## Your Ref: PINS Ref: TR010060

## Our Ref: MDC/A12/PINS/28/06/23

## RE: ARBORICULTURAL CONCERN AT BLUE MILLS NATURE RESERVE, WICKHAM BISHOPS, MALDON

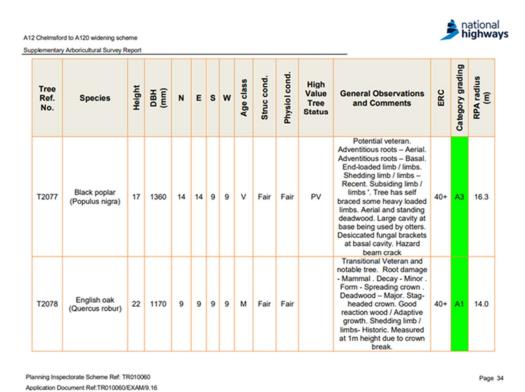
- National Highway's report (9.16 Supplementary Arboricultural Survey Report [REP3-008], p7) confirms that the Black Poplar already meets the requirements of being classed as a veteran tree and is therefore not a potential veteran. Knowing this, National Highways should increase the buffer zone it is proposing around the specimen, and the final design of the gas pipeline's routing should allow for full clearance of the RPA. National Highway's report instead seems to propose to provide

veteran trees with an RPA of 12 times stem diameter, which is the incorrect clearance for veteran trees which should be 15 times as outlined in Government guidance<sup>2</sup>. The extract below is from the *9.30 Supplementary Arboricultural Survey Report* (January 2023) p34. Based on the multiplier discussed for veteran trees, the RPA should be 20.4m (1.36m (1360mm stem diameter) x 15m), however as can be seen, the tree has only been given an RPA of 16.3m, which is the sum of 1.36m x 12m, which is the incorrect multiplier.
